**Southeast Planning Review and Adjustment Committee /  
Comité de révision de la planification de la Commission du Sud-Est**  
Wednesday, September 28, 2022 / Le mercredi 28 septembre, 2022

**Staff Report / Rapport du personnel**

**Subject / Objet :** Variance Request / Demandes de Dérogation

**File number / Numéro du fichier :** 22-1634

K:\TWC\_LDEV\IAA\Moncton, New Brunswick\3 Design\CAD\PlanSheets\C6-SITE PLAN.dwg June 11, 2021 - 12:40pm

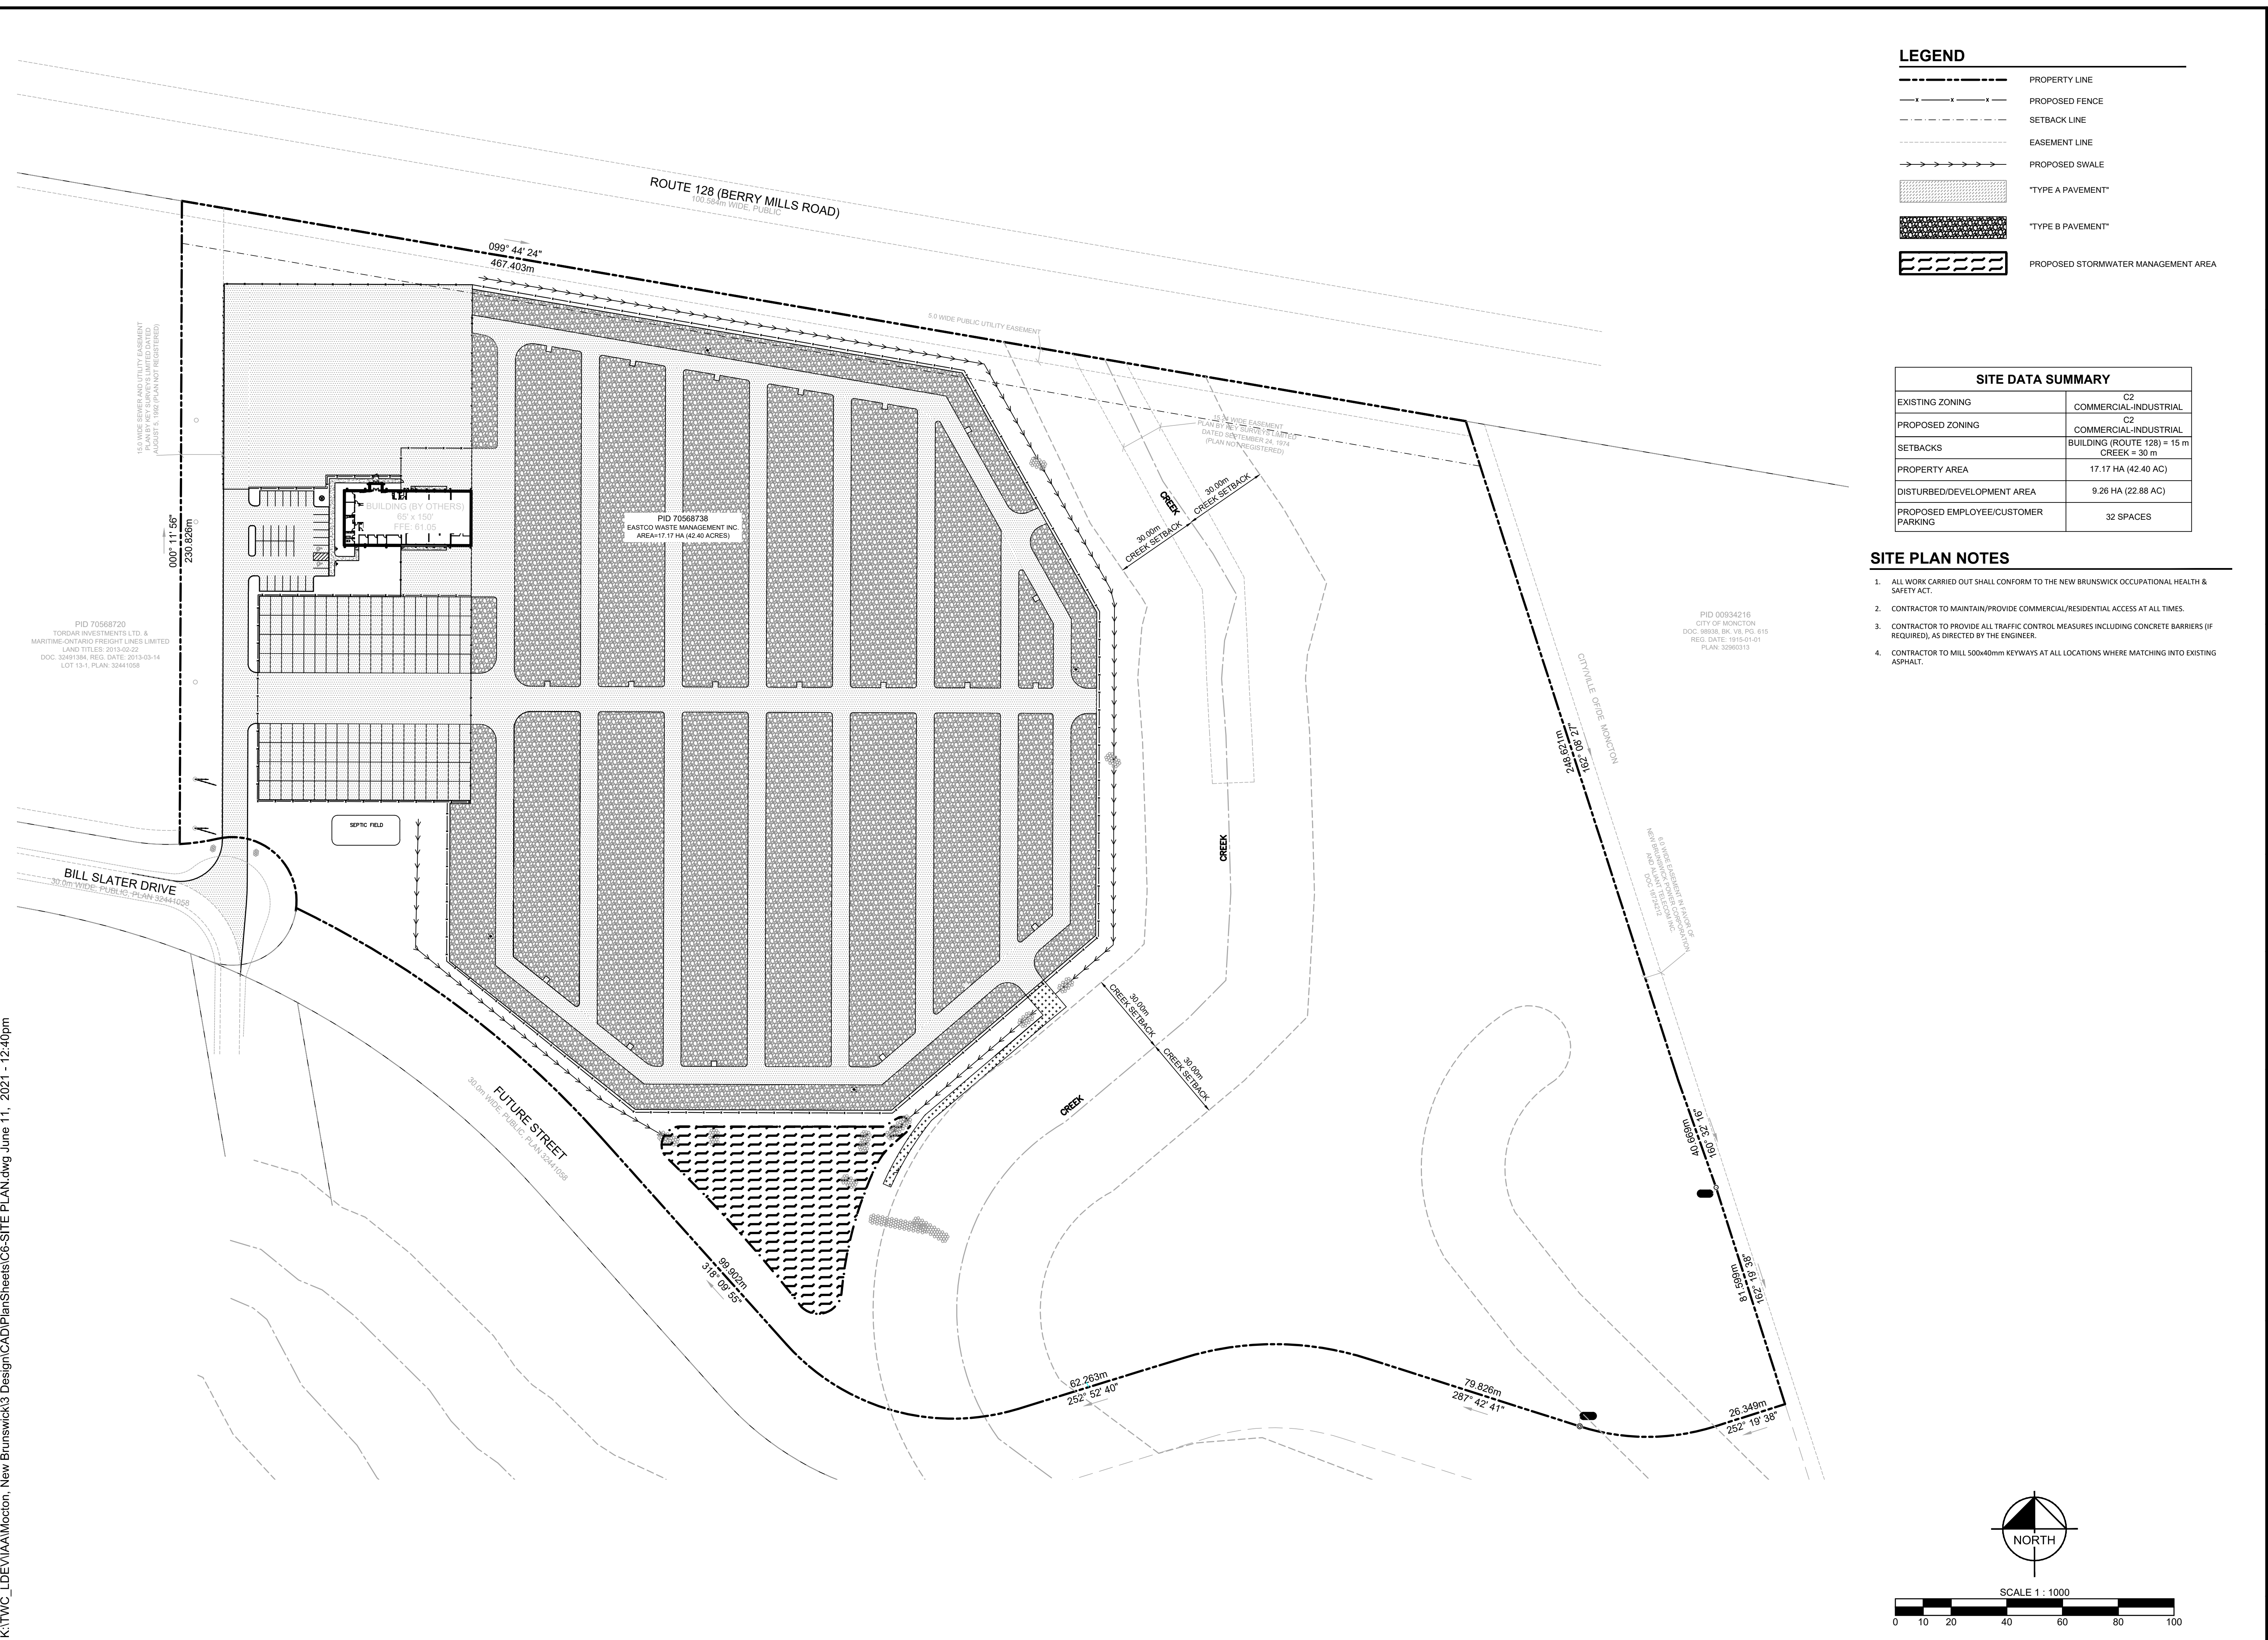
In the previously approved plan, the vehicle auction yard with associated building met the required 30-meter setback from unnamed/Jonathan Creek. The proposed new Rural Plan now requires the setback to be 100-meters. The site plan that IAA has prepared for this property would be unfeasible if the 100-meter setback requirement were to be in effect. As of June 6, 2021, IAA had received NBDTI and WAWA approvals and were substantially complete with site clearing. The selection of this site is optimal for IAA in that it fits their business expansion that has been in planning since 2020, it meets the guidelines provided by the Southeast Regional Service Commission, aside from the recent adoption of the 100-metre watercourse setback associated with this type of development.

Under the previous and current regulations, stormwater management was not required for this site as it is outside of City limits. However, IAA went above and beyond the regulations by providing temporary and permanent erosion control and stormwater management features in order to provide additional protection to the Creek.

Erosion control measures shown within the plans address the concerns of sediment compromising the stream. The first method shown to prevent this is a series of diversion ditches that border the proposed work limits and eliminate direct runoff into the creek. Within the drainage ditches, permanent haybale check dams are to be placed to limit the sediment that would reach the temporary sediment trap. The sediment trap is the second method to prevent compromising the stream. The third method proposed to control sediment transport during construction is the silt fence that surrounds the site and is to be maintained regularly if sediment were to build up along with the two other measures. In the case of an extreme rain event, the overflow from the sediment trap is designed to be routed through a section of rip rap followed by silt fence to limit the amount of sediment transport. Similar methods of erosion control will be implemented within the second phase of the development with the addition of inlet protection measures. The temporary sediment basin will be converted to a permanent stormwater detention pond (dry pond) that provides storage to reduce the peak runoff rates leaving the site. Please see the attached table below with post-development rates if the stormwater pond was not installed and installed. There is a 68% reduction in the event of a 100-year rain event and a 66% reduction of runoff for the 2-year rain event. As outlined in the proposed construction plans, an inline hydrodynamic separator (CDS) structure will be

placed at the site discharge point to provide continued pollutant reduction and stormwater quality control prior to entering the Creek. This structure will provide an additional line of protection to the creek from sediment and other pollutants by providing a net annual removal rate of 82.70%. Please see the attached report from Contech for removal rates.

2 – YEAR	100-YEAR
POST-DEVELOPMENT WIHTOUT STORMWATER BASIN (L/s)	1,205	3,287
POST-DEVELOPMENT WITH STORMWATER BASIN (L/s)	400	1,050
